Bike Winnipeg April 2016 Executive Director's Report

Bike Winnipeg Downtown Protected Bike Lanes & West Alexander Discussion Meeting Notes

Bike Winnipeg Recommendations Pembina Highway Rehabilitation Project – Osborne to Grant

Potential Cross Sections for Option 3 Utilizing Hardstand Areas interspersed with Parking

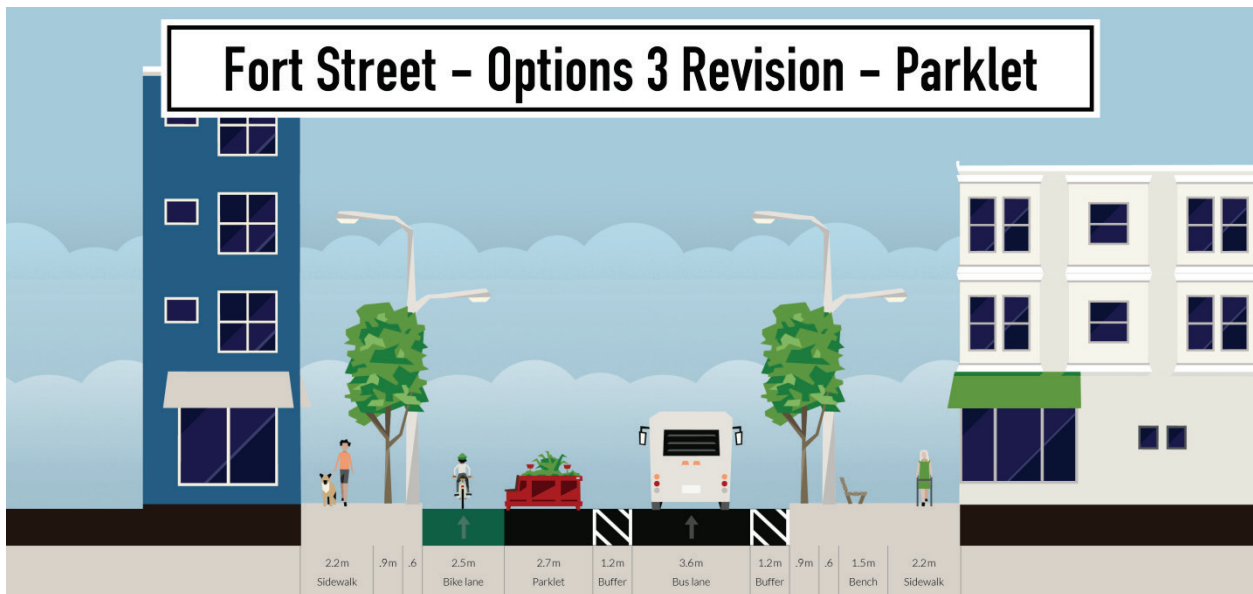
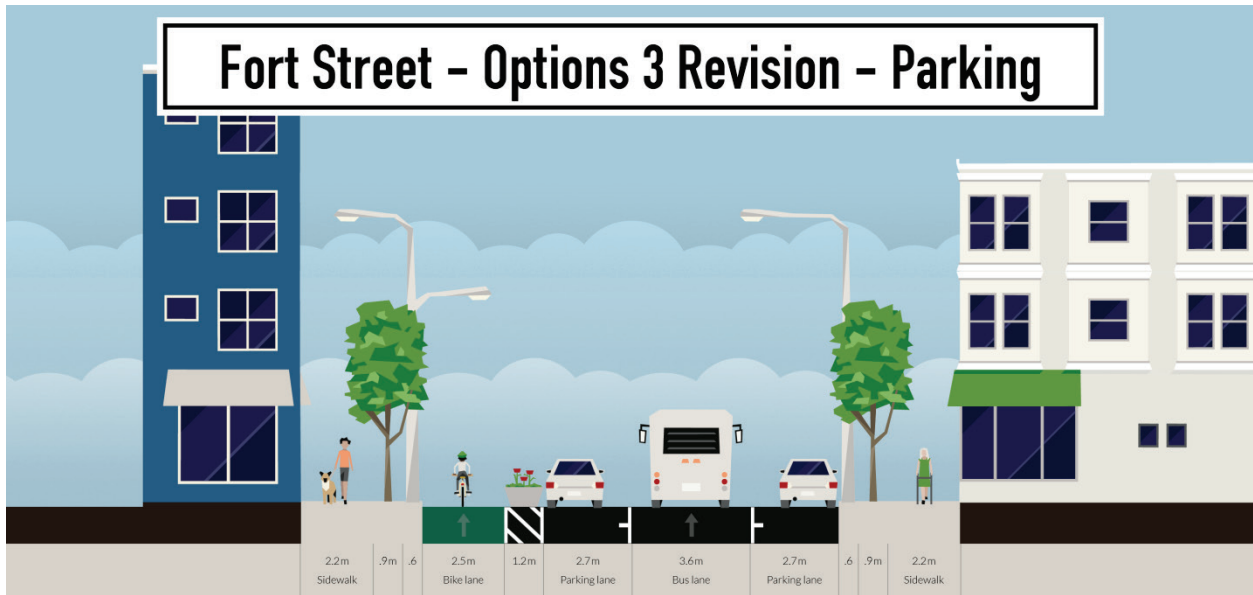
- Widen the bike lane to at least 2.5m
 - Easier to plow
 - Matches anticipated/desired capacity
 - Unlike people driving motorized vehicles who tend to travel at the same speed, people riding bikes will have much more variation in speed
- 6m access is a requirement for Fire and EMS vehicle access.
 - [NZ guidelines](#) note that the 6m requirement is needed to allow stabilizers to be deployed when aerial equipment (such as a ladder?) needs to be used.
 - Might be able to get away with a narrower lane that is interspersed with well-placed 6m wide sections called hardstand areas where stabilizers could be deployed

- This would allow for a 4m travel lane that would in turn allow for 2.5m parking lanes interspersed with 1.5m landscaping/placemaking breaks that would double as snow storage space in winter.

- Or 2,7m parking and 3.6m travel lane.
 - Also allows for much wider bike lane, buffer, and sidewalk/sidewalk buffer zone.
 - Could easily add trees to Fort for aesthetic/climate improvements.

Confusion Corner Connectivity

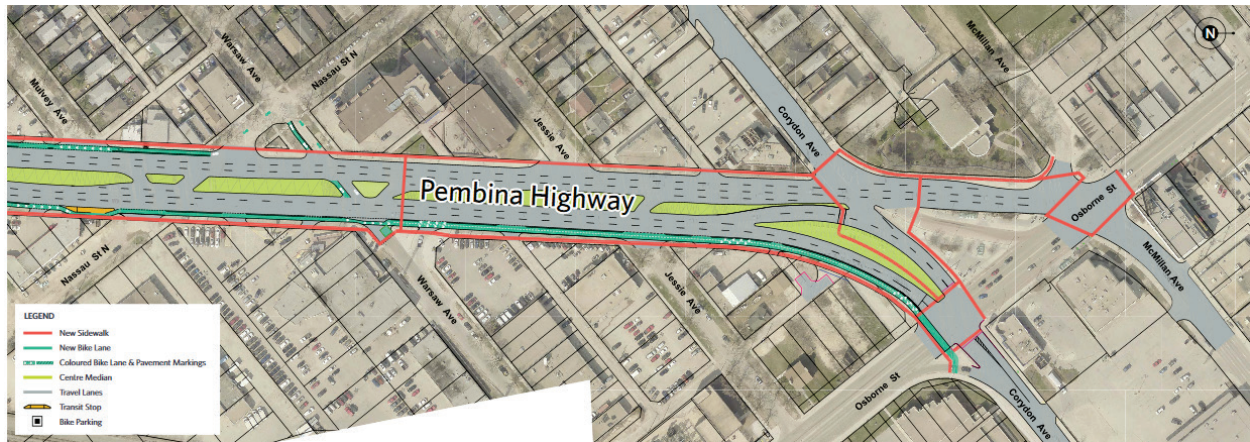
At the north end of the work being proposed, people on bikes will need to be making the following connections:

- Nassau Street (Existing Neighbourhood Greenway)
- Warsaw Avenue (Existing Neighbourhood Greenway)
- McMillan Avenue (Planned Neighbourhood Greenway)
- Corydon Avenue
- Donald Multiuse Pathway (Existing)
- Pembina Highway Buffered Bike Lanes (planned)
- Osborne Street Bike Lanes (planned)

Add a two stage turn queue and pathway to accommodate people biking north on Pembina towards destinations north of Corydon

Maintain crossing on separator island to allow people biking south on Osborne to get ahead of southbound traffic in advance of the Osborne Underpass

We are concerned that the plans to eliminate the crossing of Pembina on the separator island eliminate a useful connection between destinations north of Corydon and South Osborne.

- **Corydon – Osborne Connection**

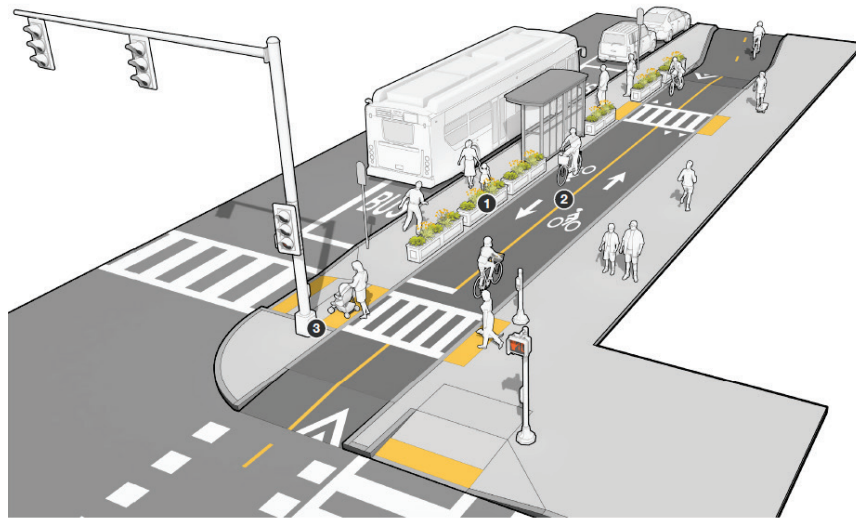
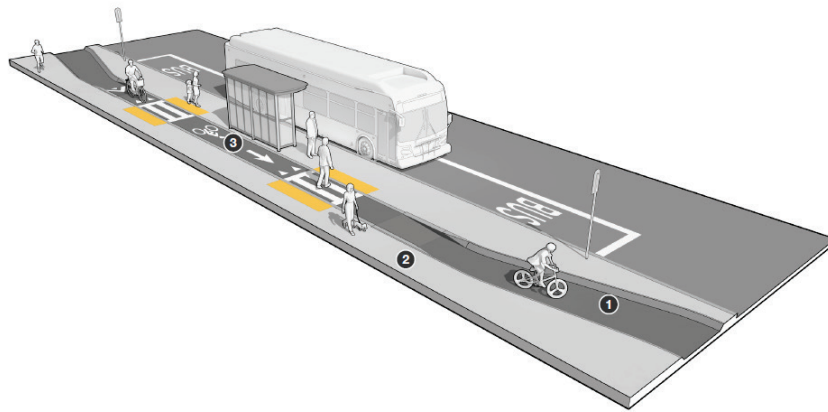
- The connection from Corydon to southbound Osborne needs to be maintained and improved upon.
- Currently, a person biking from north of Corydon headed towards south Osborne has the ability to approach Pembina on Corydon and cross Pembina within one traffic signal phase to reach the corner of Pembina & Osborne in front of eastbound traffic, continuing south through the Osborne Underpass while traffic on Osborne is stopped at Pembina. This creates a good lead time for a person biking south, and provides a reasonable degree of comfort.

- The proposed redesign of the island separating northbound traffic from eastbound and southbound traffic on Osborne/Corydon will prevent a person on bike from making the turn onto southbound Osborne until southbound traffic on Osborne gets the green light, removing the lead time they have that currently allows them to get through the Osborne Underpass ahead of southbound traffic.

- We would not want to see this crossing removed before protected bike lanes are installed on Osborne when the Osborne Underpass is rehabilitated.
 - Similarly, anyone who is trying to connect to the pathway along the south side of Donald will have to wait for traffic on Osborne to stop before reaching the two way cycle track along the south of Corydon that parallels the transitway, resulting in a significant loss of service.

- **Daly Crossing**

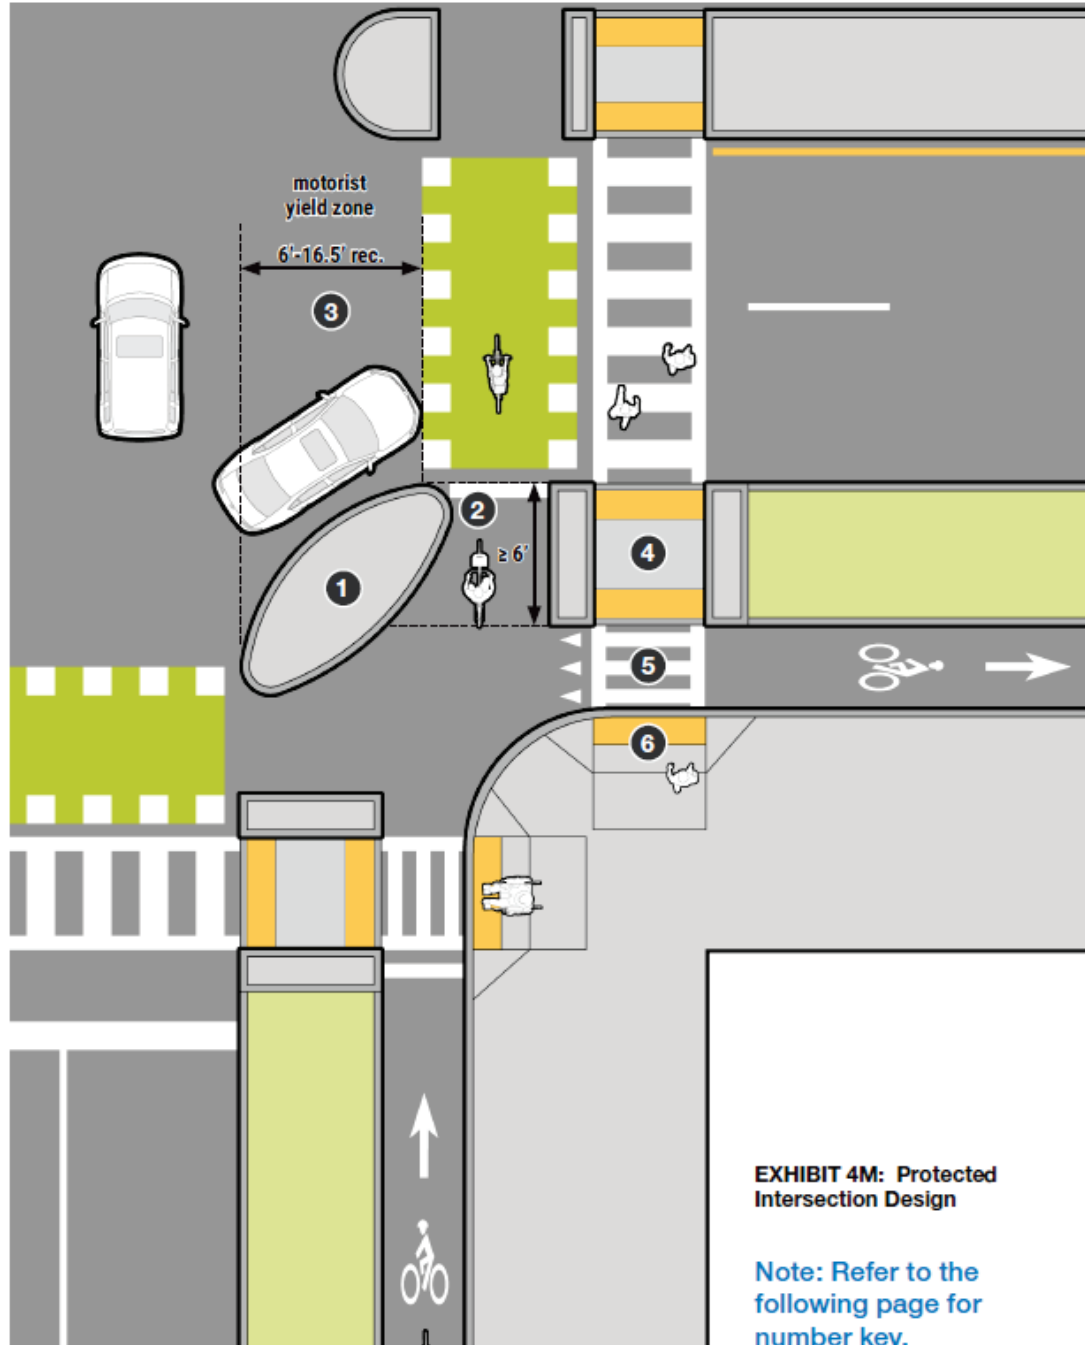
- Ensure that there is an easy and logical way for people on bikes to activate and then cross Pembina with the existing lights.
- Ensure that people on foot and bike are separated at this crossing.
- Allow for jug handle turn in NB Pembina
